PERRY TOWNSHIP, FRANKLIN COUNTY, OHIO  
**SANITARY SEWER IMPROVEMENT PLAN**  
**THE COTTAGES AT BROOKSIDE**  
**FOR**  
**BG & CC DEVELOPMENT COMPANY LLC**  
 SANITARY TRIBUTARY MAP

CITY OF COLUMBUS DEPARTMENT OF PUBLIC UTILITIES APPROVED TIFF IMAGE FOR REVISION

Drawing Number:  
**4 / 8**

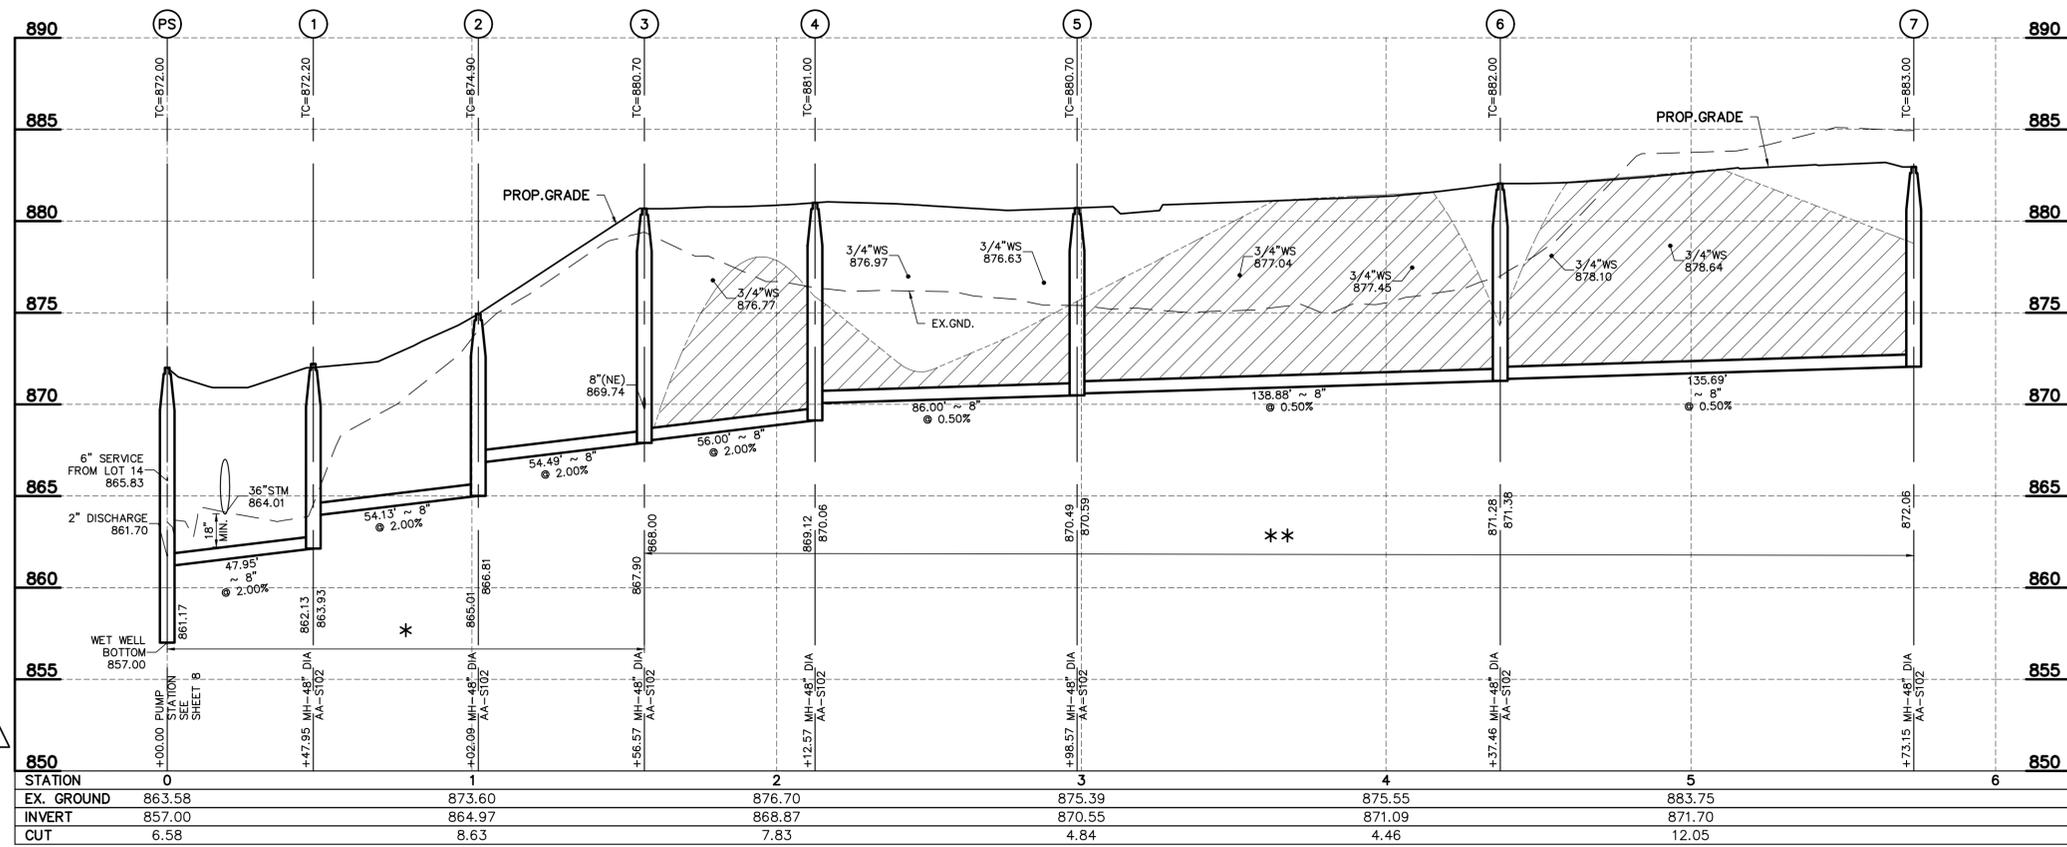
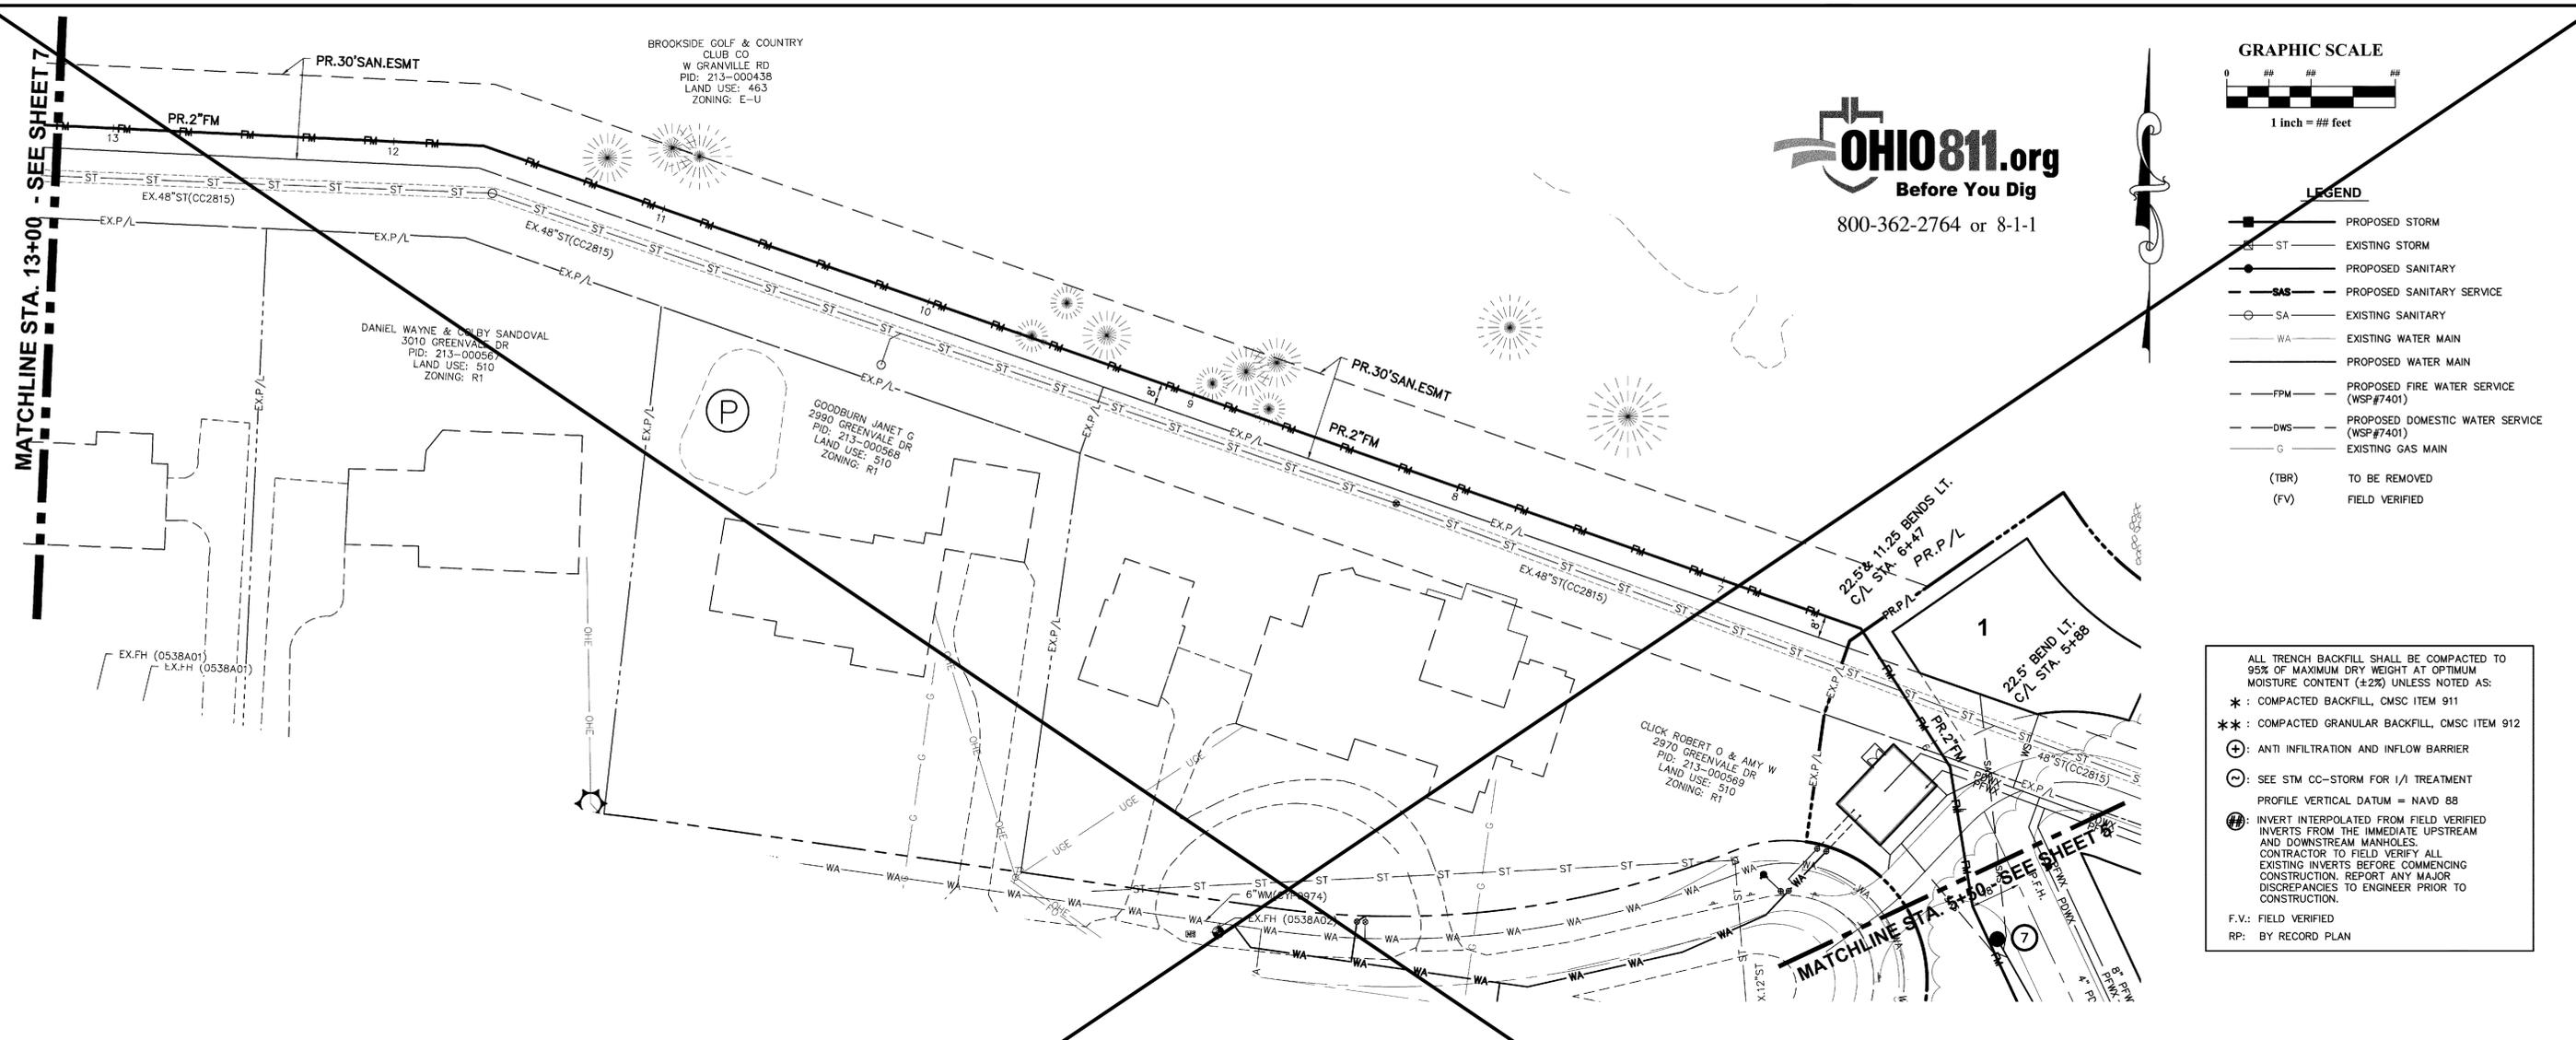
No.	Revision	Date	Approved
1	MOVED PUMP STATION, MODIFIED PROFILE DESIGN FOR STRUC. PS-4

Drawing Number:  
**6A / 8**

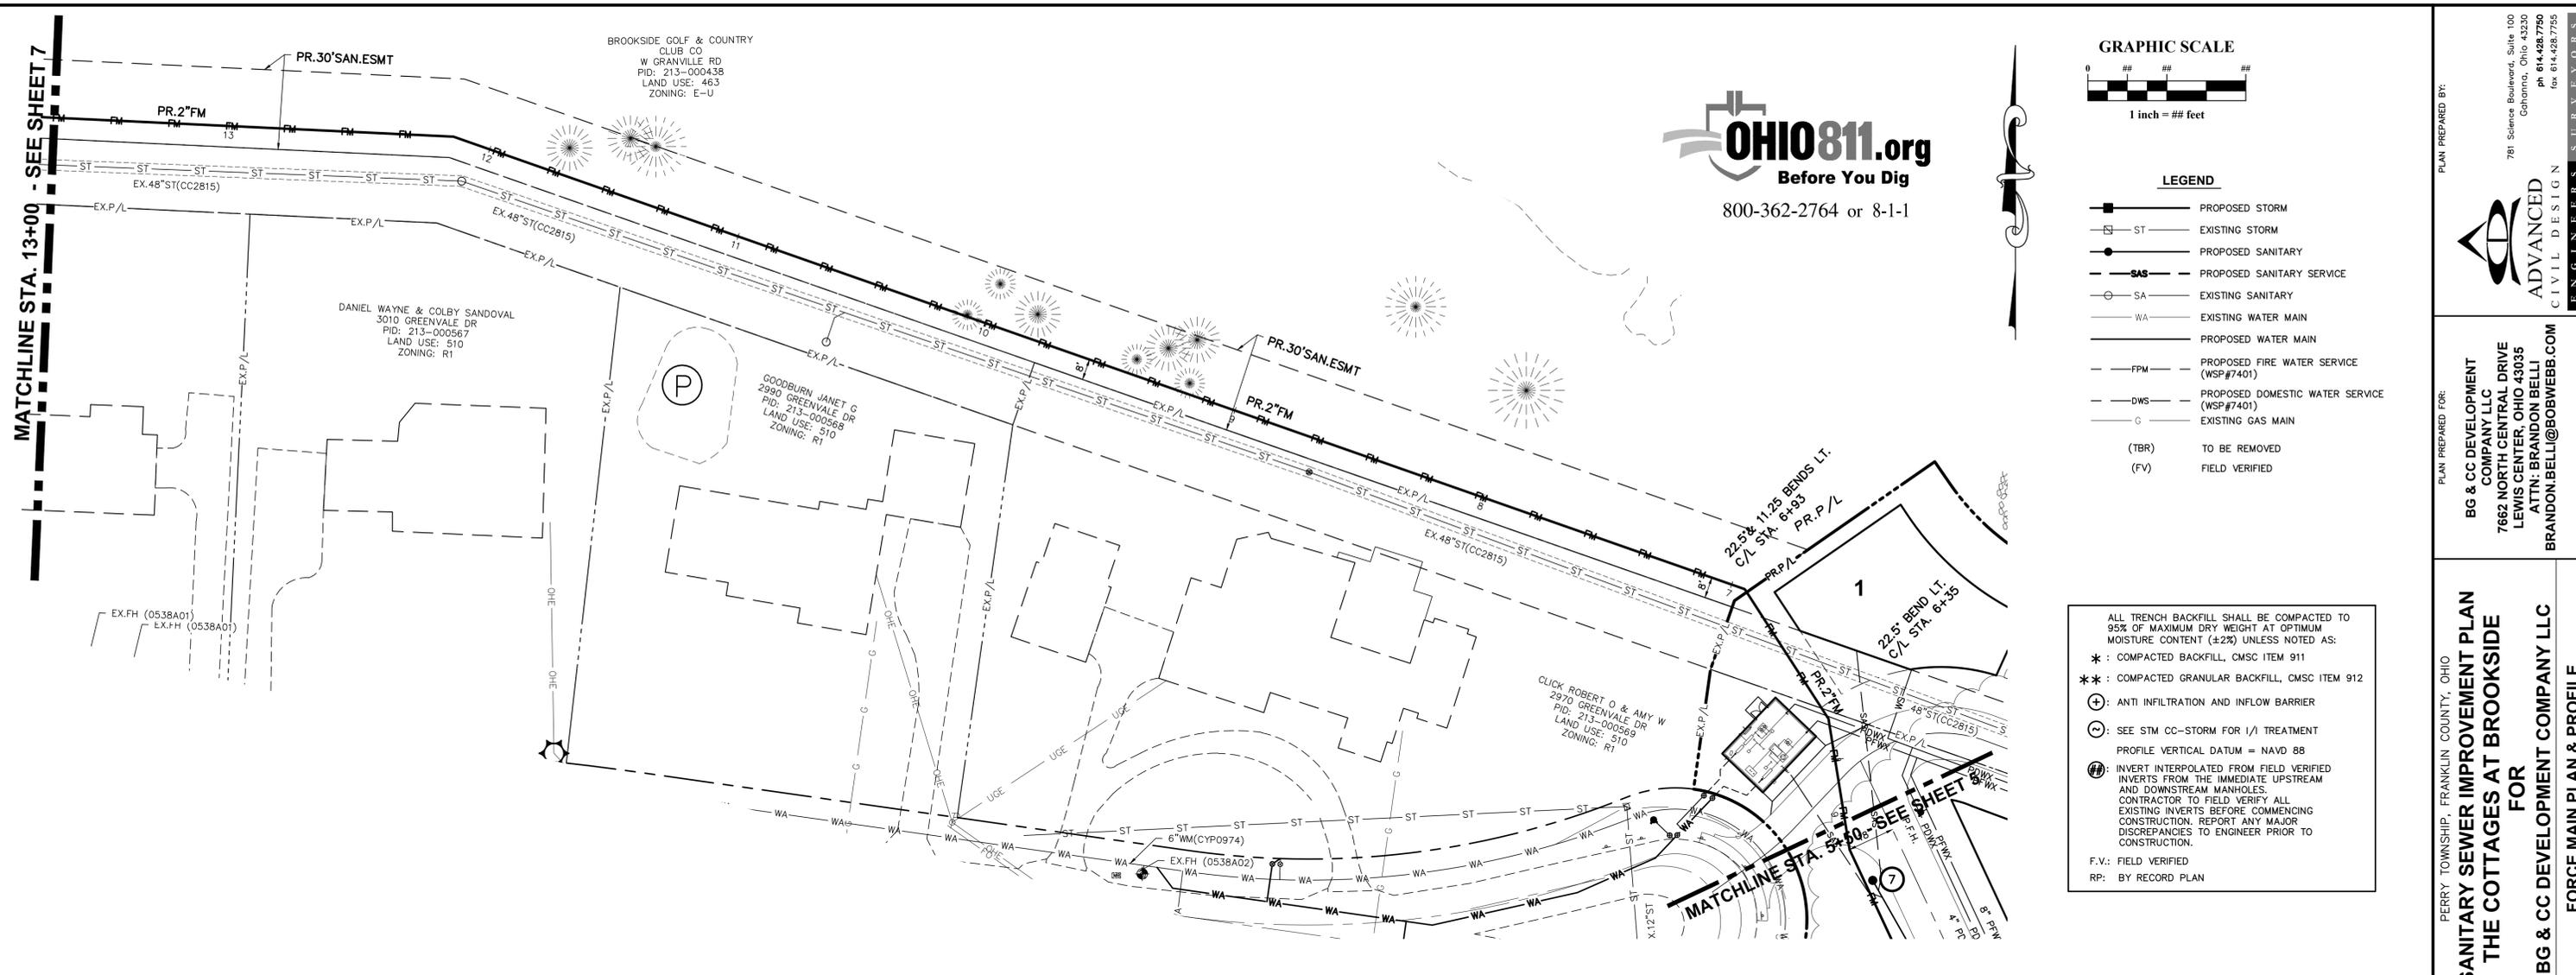
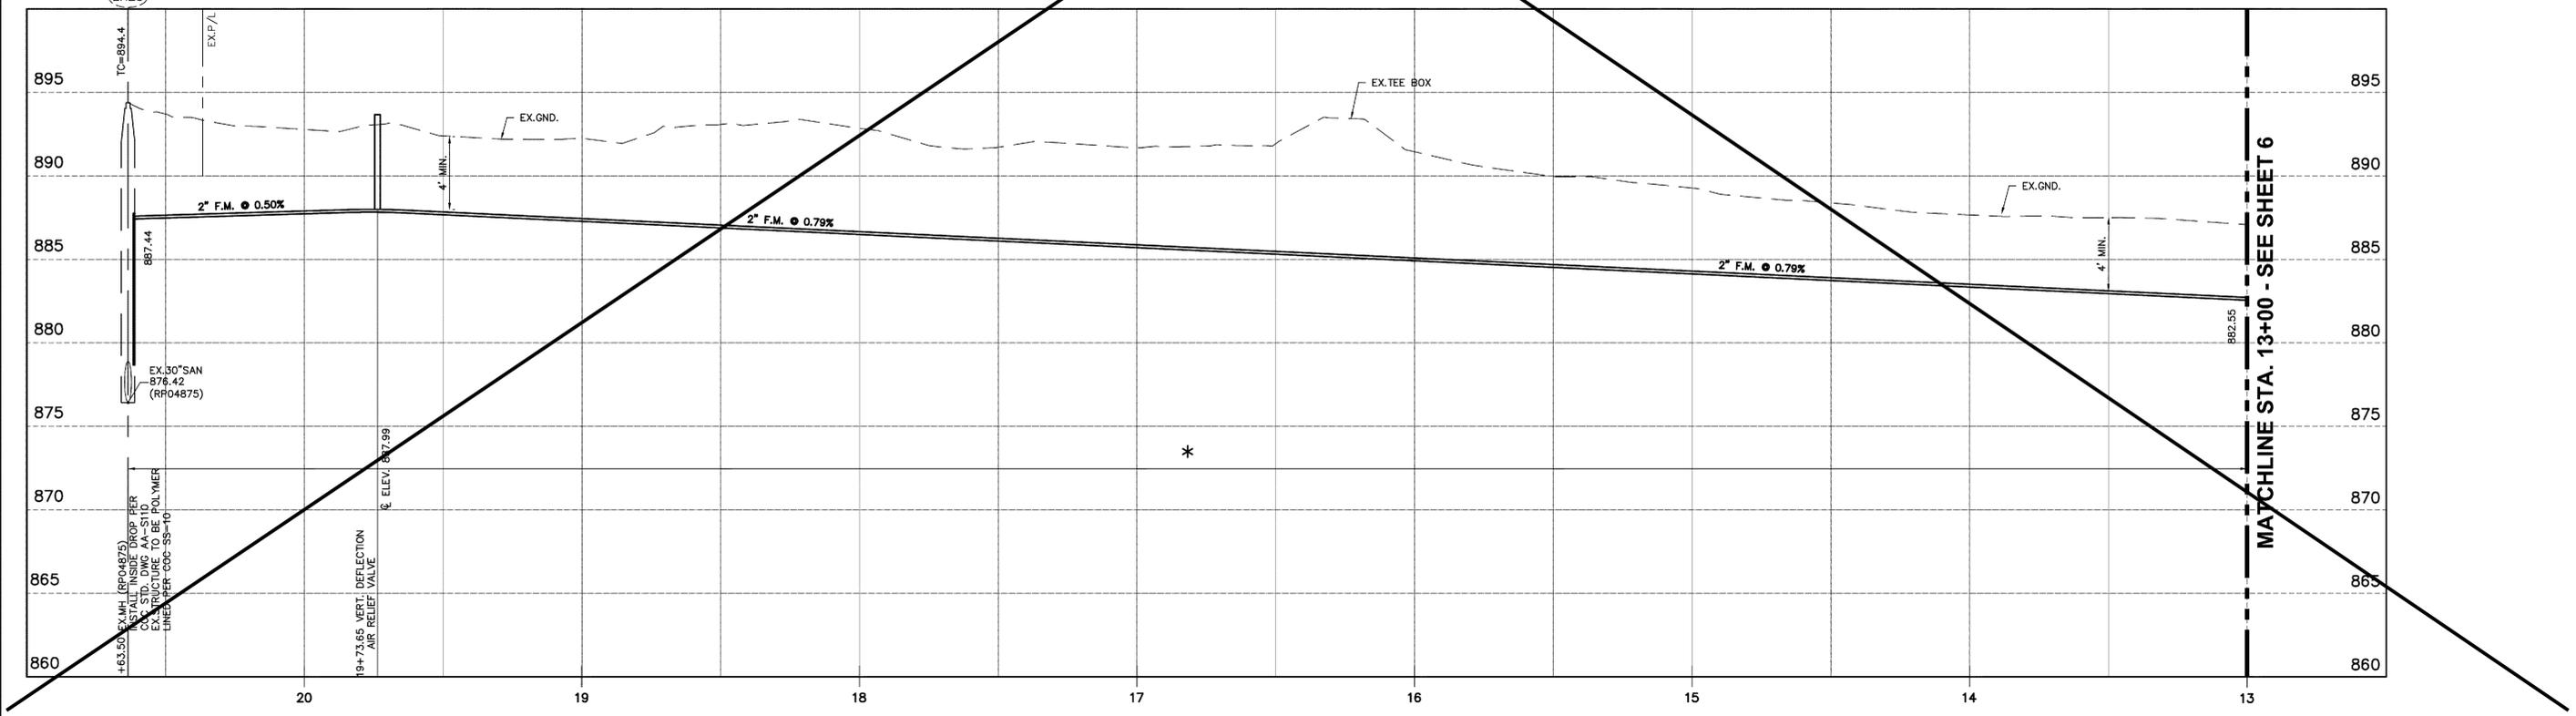
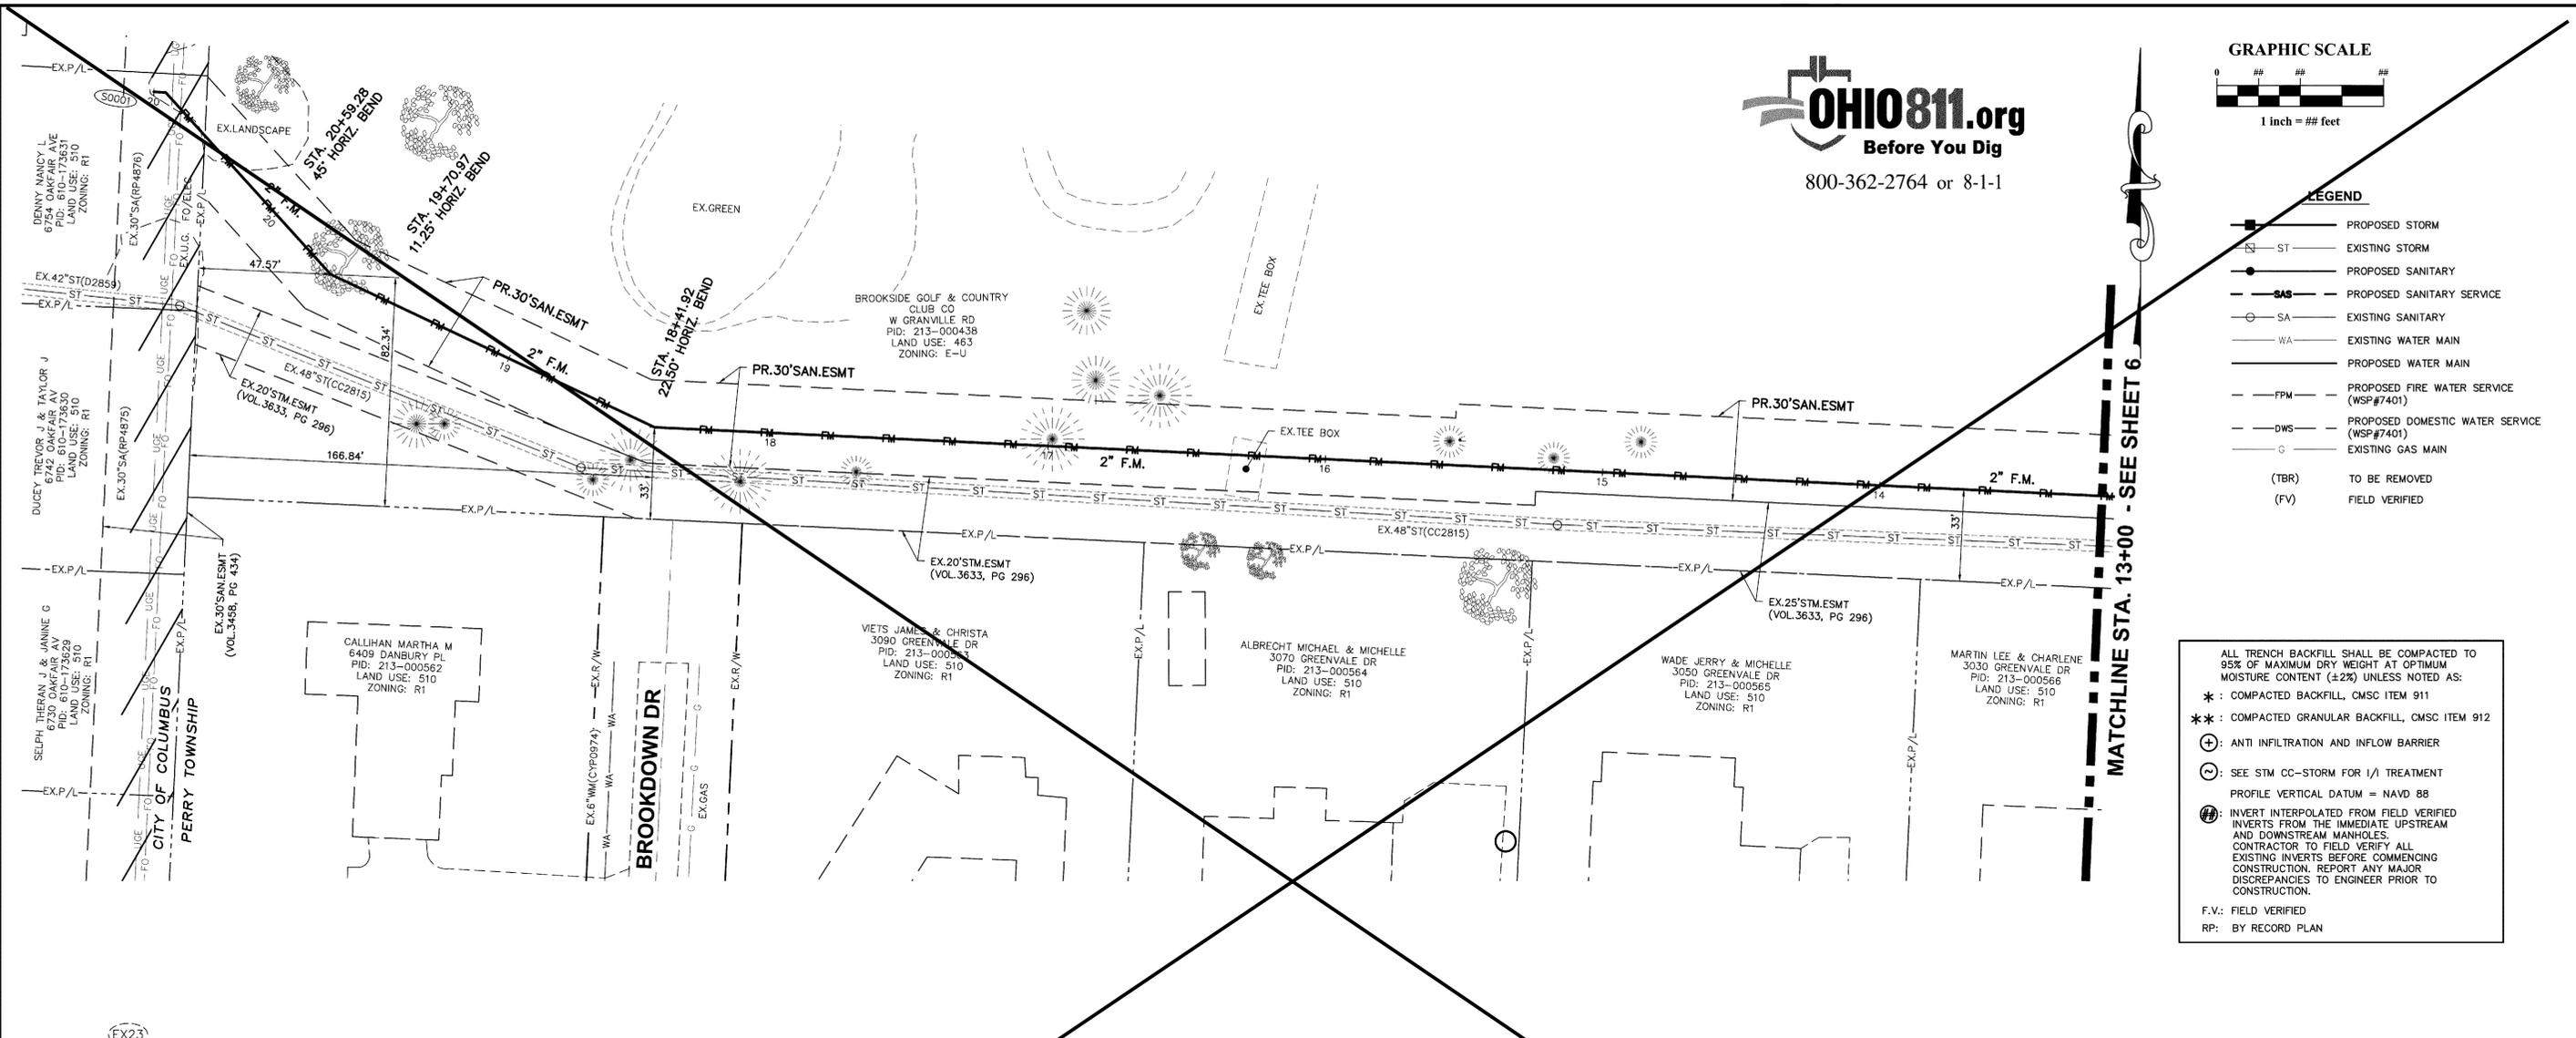
No.	Revision	Date	Approved
1	REVISED FORCEMAIN PROFILE DESIGN
